ADDENDUM #1

CR 565/Villa City Road from North of SR 50 to South of US 27

Project No. 2024-01, Bid No. 25-517

FPN #447609-1-58-01

Cross-section view of an overlay with the SafetyEdgeSM. Source: FHWA-SA-17-044

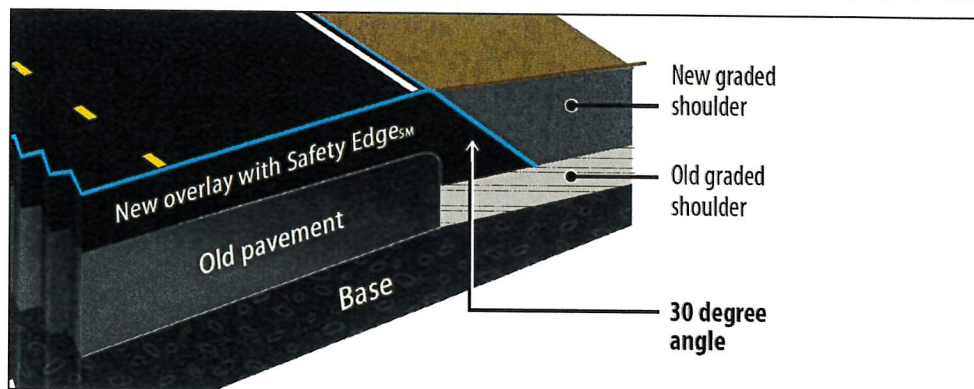
Q10: Please provide additional details on the safety edge called out in the typical sections.

A10: Please see attached Safety Edge detail
